S E R V I C E N O T E

70100A Power Meter

Modification to Eliminate Loose Reference Oscillator N-type connectors

Page 2 Service Note 70100A-01

Figure 1

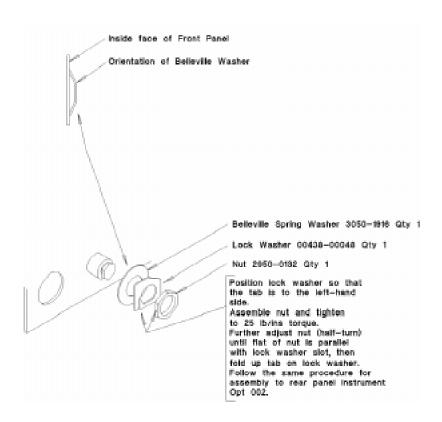
Multiple connections of power sensors to the Reference Oscillator, together with the weight of the sensor, have been causing lateral movement on the connector which has distorted the mounting hole on the front panel. This has in turn allowed the retaining nut to rotate backwards and make the connector even looser. Tightening the nut has fixed the problem in the past but the problem has re-occured in some instances because the front panel hole distortion still exists.

A new fixing mechanism has been introduced which includes a spring washer and a lock washer. If the hole distortion occurs these two washers ensure that the nut remains under tension and cannot rotate. The connector therefore does not come loose. The instrument will need to be stripped down to give access to the rear of the Reference Oscillator connector on the front or rear panel. See Figure 1. for instructions on how to put on the new fixing hardware.
